FILE NH-IM-95-1(116)&(131)Camden County OFFICE Preconstruction
P.I. Nos. 511080&511081
DATE January 3, 1995
FROM  C. Wayne Hutto, Assistant Director of Preconstruction
TO SEE DISTRIBUTION

SUBJECT PROJECT CONCEPT REPORT APPROVAL

Subject: Georgia Projects NH-IM-95-1(116)(131), Camden County
NH-IM-95-1(126)(132), Camden County
and NH-IM-95-1(120)(136), McIntosh County

NH-IM-95-1(116)
NH-IM-95-1(131)
CAMDEN COUNTY

TYPICAL SECTION
 PHASE I
 SCALE = 1" = 10'

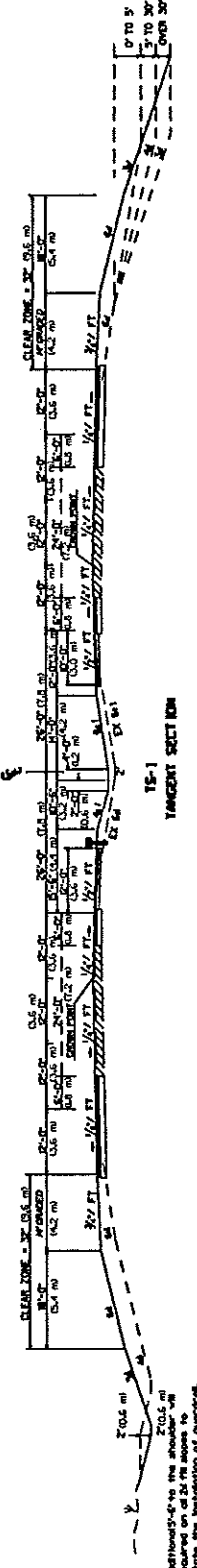
We recommend the concept for Phase I be revised to utilize the three outside lanes for traffic rather than the three inside lanes in the existing 64 foot (19.2 m) median section. This will provide a number of advantages without affecting the basic design since all grading for the Phase II section will be done on Phase I.

- 2) The overhead guide signs can be installed in Phase I at the correct locations for use on Phase II. If the inside lanes are used, the gore location of exit ramps will shift on Phase II requiring relocation of the exit direction signs. The advance guide sign structures would also have to be relocated, or sign bridges used, since the maximum length of cantilevered sign structures is presently 40 feet.
